**RE: PRMRWSA Regional Integrated Loop System – Phase 3A Interconnect and
Final Report – Central County Leachate Forcemain (LFM) – WACS 51614**

As requested by FDEP (email dated March 01, 2011 from Melissa Madden), Atkins is submitting the final report for impacts to the leachate forcemain that occurred during the construction of the PRMRWSA Phase 3A Interconnect project.

RECORD DRAWING
INCORPORATING CHANGES MADE TO THE EXISTING
LEACHATE FORCEMAIN BASED ON NON SURVEY FIELD
COLLECTED DATA. AS SUCH THE LOCATIONS DEPICTED
SHOULD BE CONSIDERED APPROXIMATE.

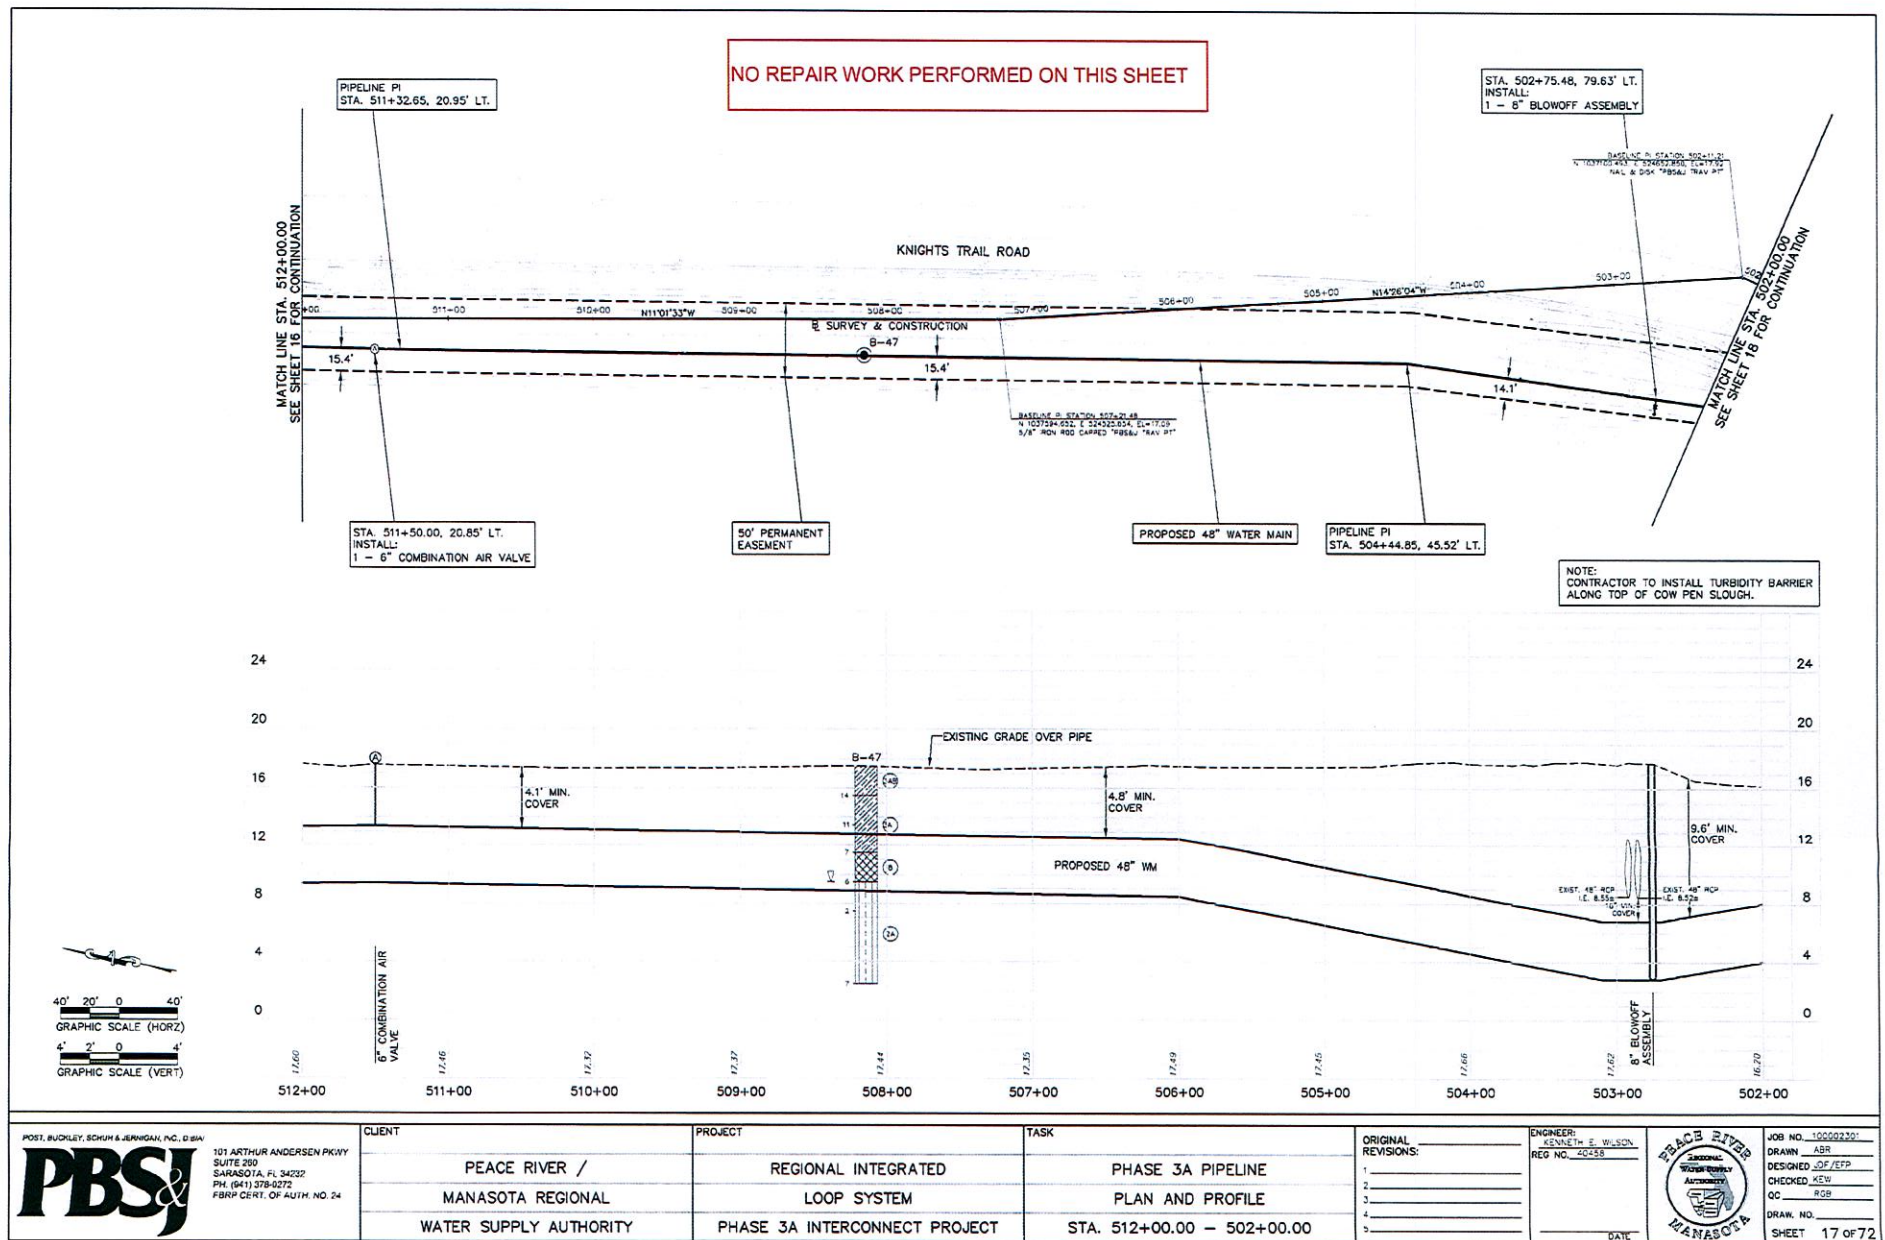
Leachate Forcemain Repair
3/28/2011
Station 525+00 +/-
N 27° 11.543'
W 82° 24.342'

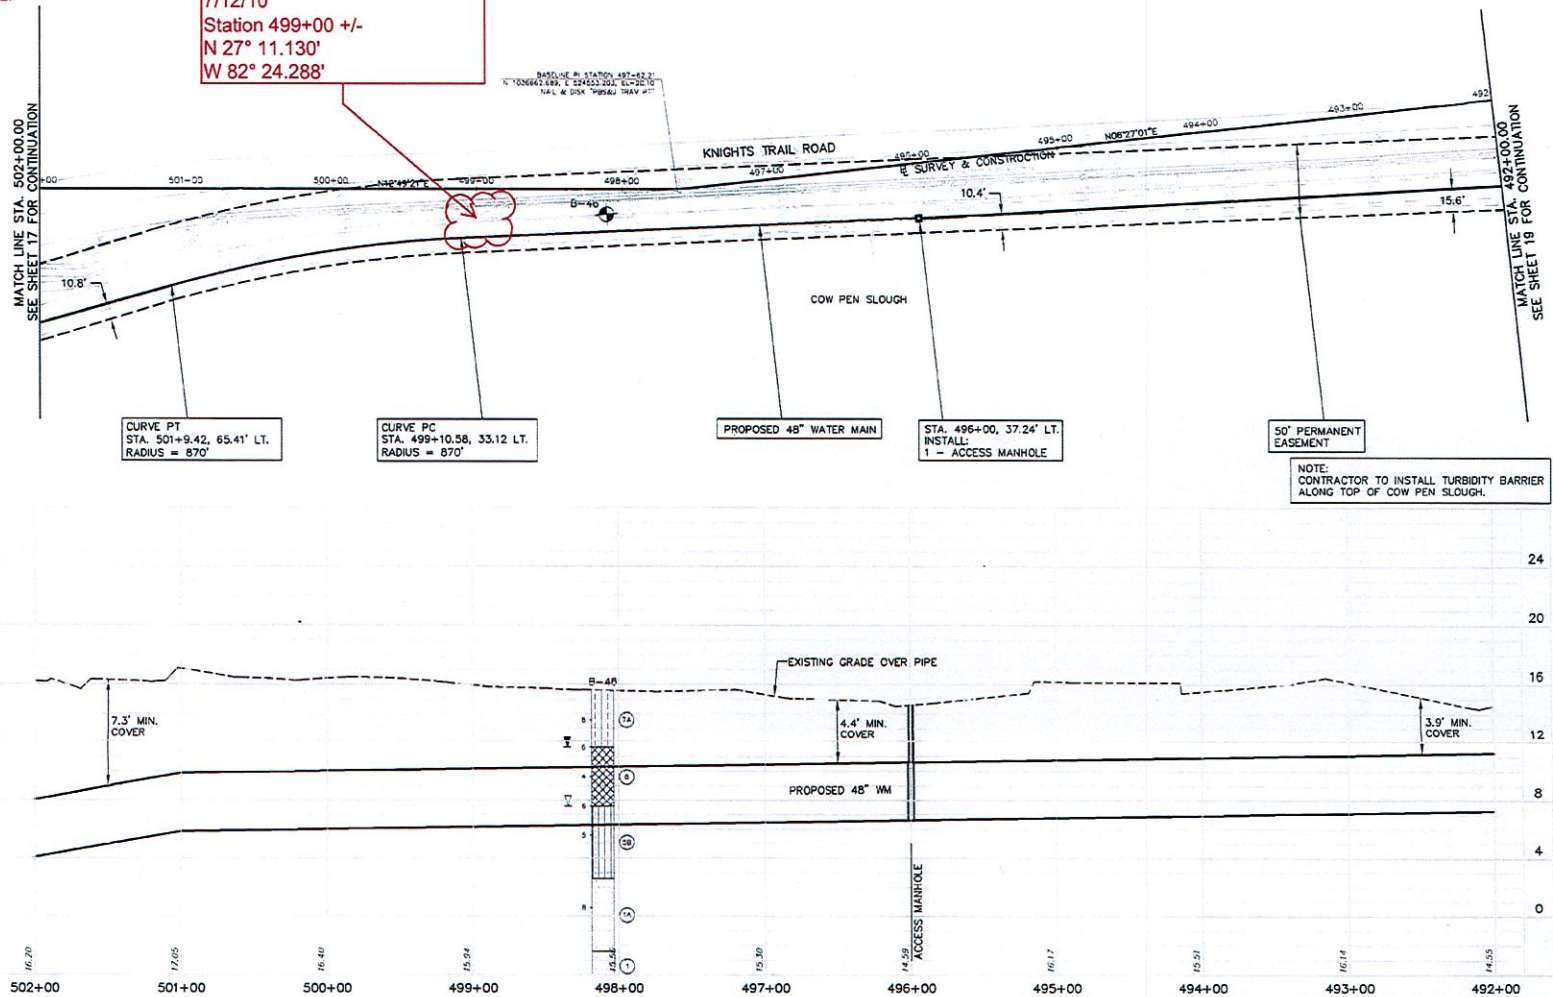
Leachate Forcemain Repair
7/12/10
Station 499+00 +/-
N 27° 11.130'
W 82° 24.288'

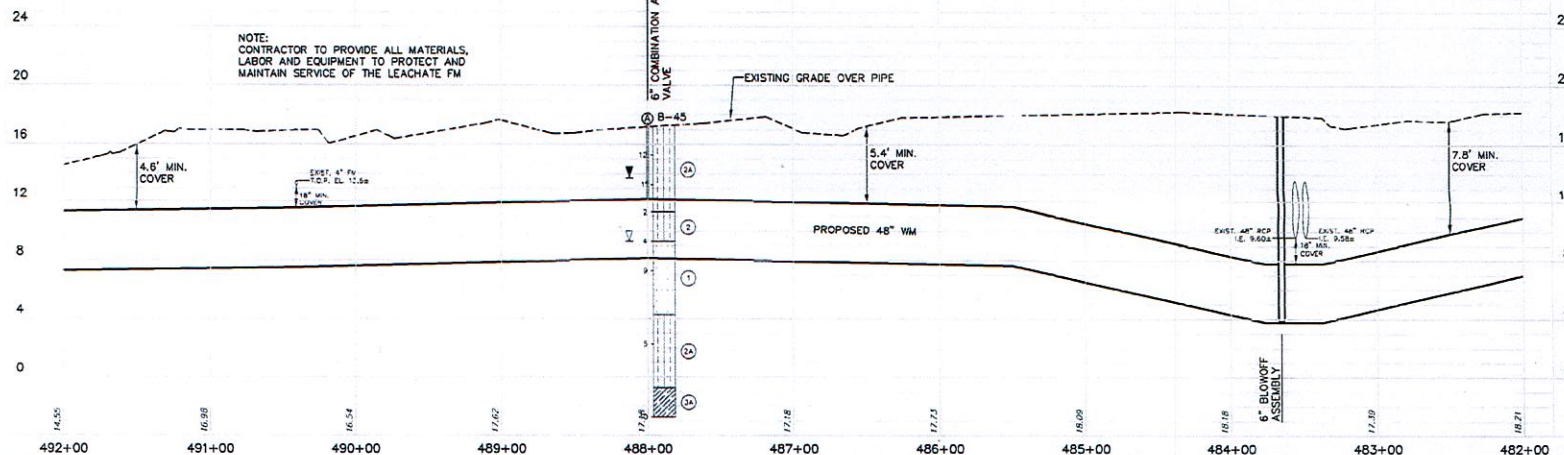
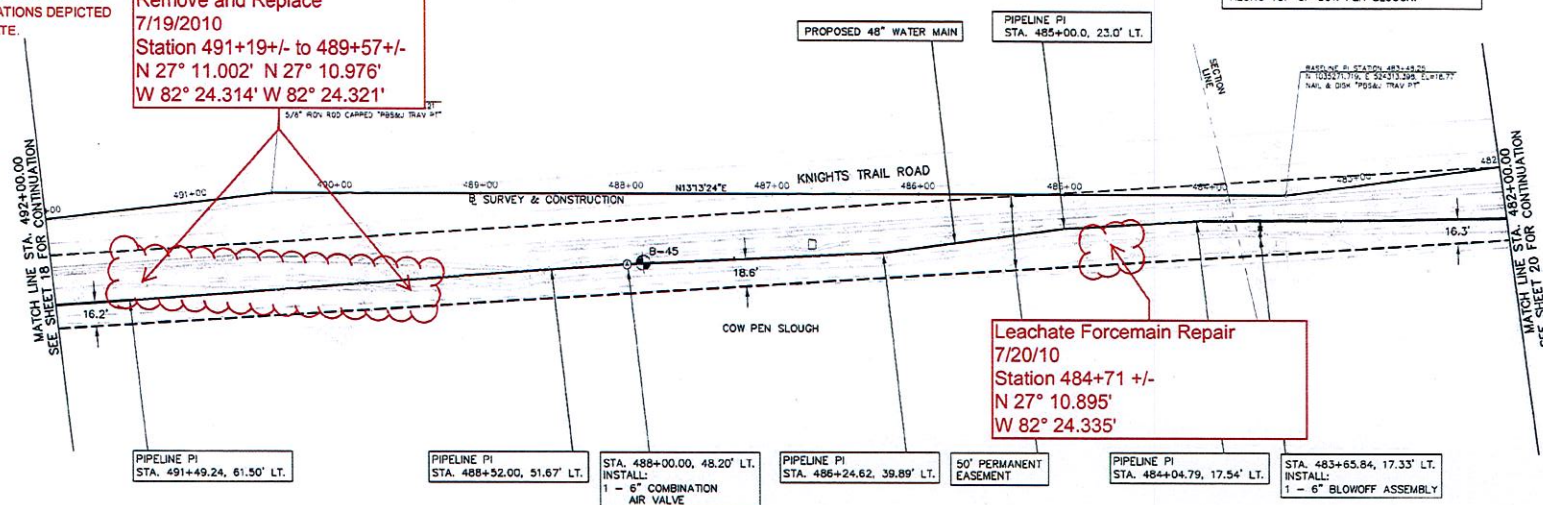
Leachate Forcemain
Remove and Replace
7/19/2010
Station 491+19+/- to 489+57+/-
N 27° 11.002' N 27° 10.976'
W 82° 24.314' W 82° 24.321'

JOB NO. 100022301
DRAWN ABR
DESIGNED JDT/ETP
CHECKED KEW
QC HGB
DRAW. NO.
SHEET 24 OF 72

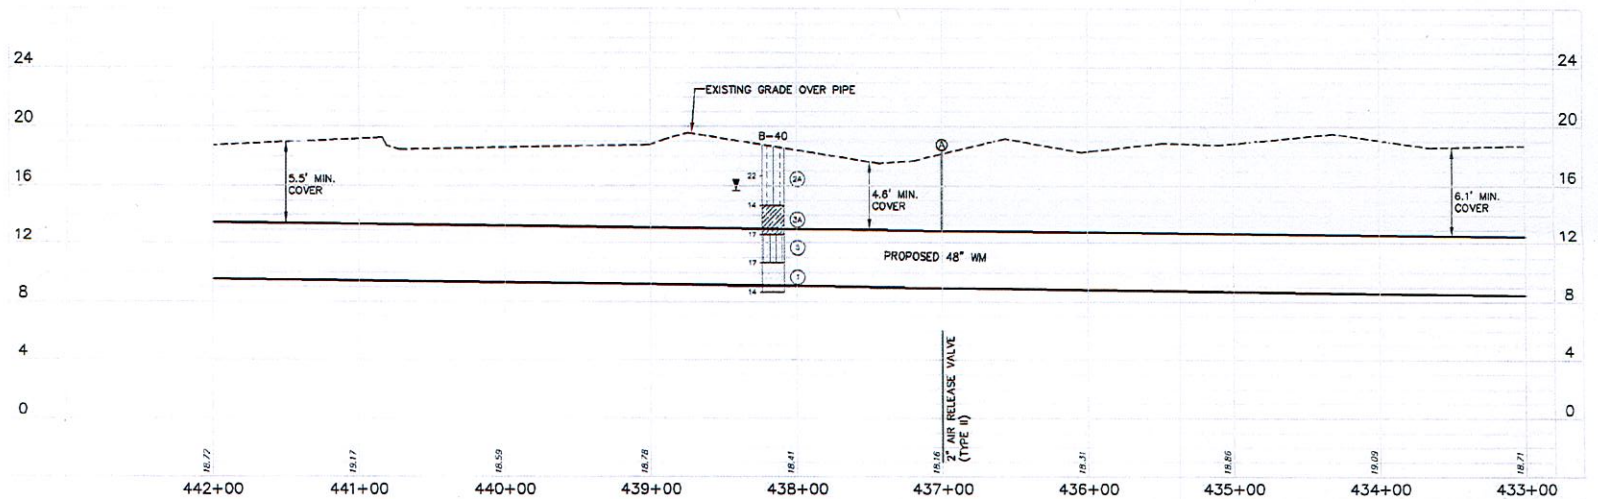
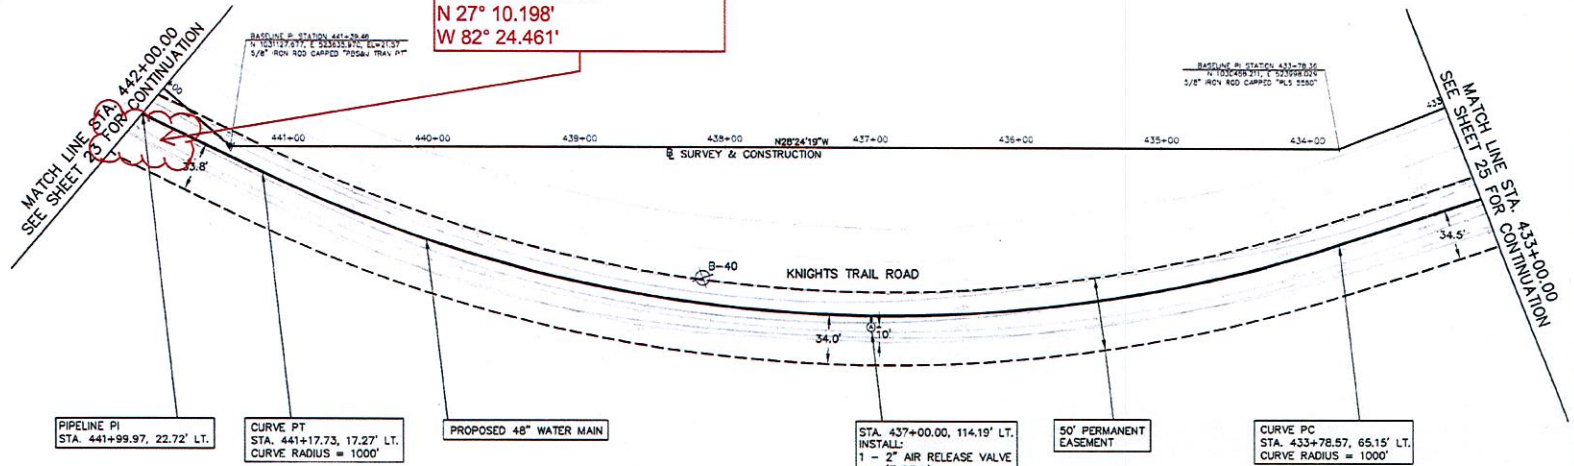
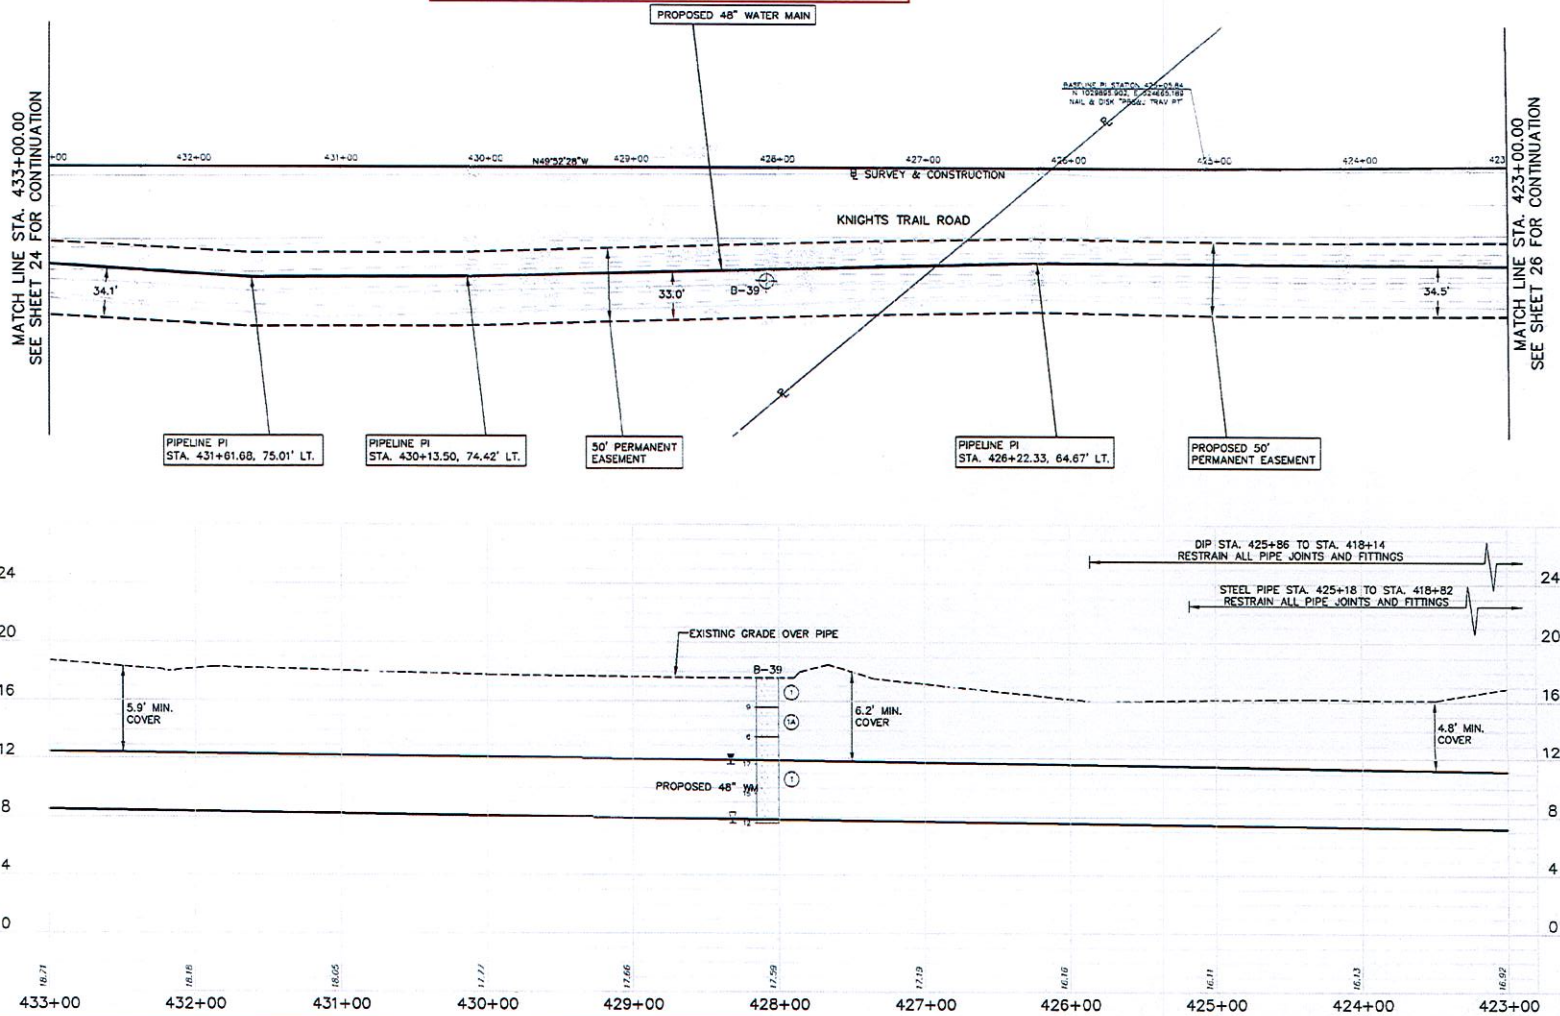
Leachate Forcemain Repair
3/17/2011
Station 441+85 +/-
N 27° 10.198'
W 82° 24.461'
